HISTORIC LANDMARK COMMISSION
APPLICATION FOR A CERTIFICATE OF APPROPRIATENESS
OCTOBER 28, 2019
C14H-2000-0002
ROYAL ARCH MASONIC LODGE
311 W. 7TH STREET

Construct a multi-story addition to the building.

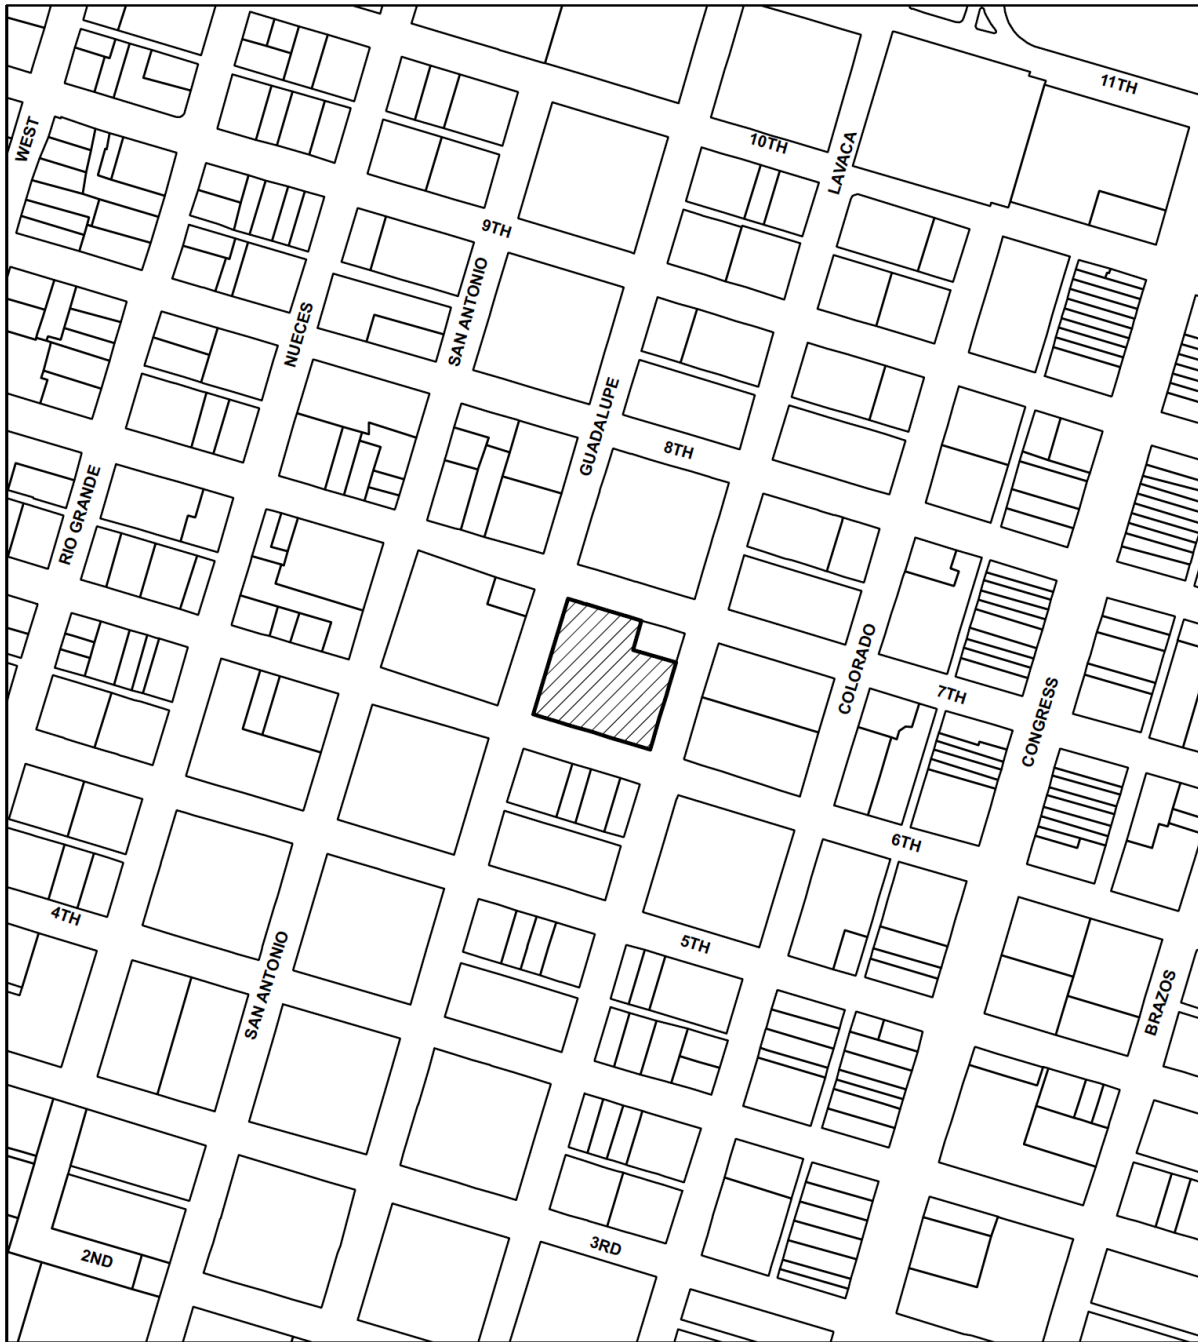
The Committee recommended that the applicant lighten the tower as much as possible with a more pronounced break between the existing building and the tower addition. The Committee also recommended that the applicant provide a detailed structural stability plan for bracing the historic masonry walls during the course of construction and when complete. The applicant has provided the bracing plan as well as modifications to the design of the tower addition as recommended by the Committee.
